SERVICE BULLETIN

B-058

Firebolt and Lightning Fuse Running Change

Figure 1. Firebolt Models

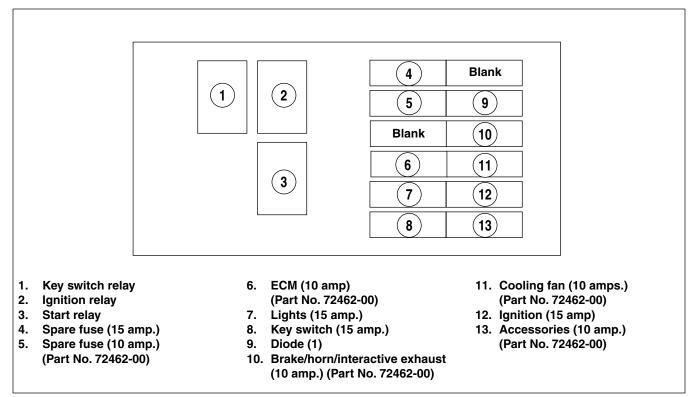
See Table 1-1.The purpose of this bulletin is to inform the dealer network of a running change in manufacturing concerning certain fuses used on 2004 Buell XB model motorcycles. 2004 XB parts and service manuals may not display the correct information. Figure 1 shows the correct ratings for Firebolt models and Figure 2 shows the correct ratings for Lightning models. Always use the fuse ratings indicated when replacing a fuse.

ELECTRICAL SYSTEM	AMPERES			
Main fuse	30 - Same			
Ignition fuse	15 - Same			
Light fuse	15 - Same			
Accessory fuse	Old - 7.5 - New - 10			
Brake/horn/active muffler fuse (XB12R only)	Old - 15 - New - 10			
ECM fuse	Old - 7.5 - New - 10			
Key switch fuse	15 - Same			
Cooling fan fuse	Old - 7.5 - New - 10

Refer to Table 1-1. Update all 2004 XB parts and service manuals to reflect this running change. There is no need to replace good fuses on vehicles built prior to this change, however, it is acceptable to use the new fuses in vehicles built prior to the running change. NOTE
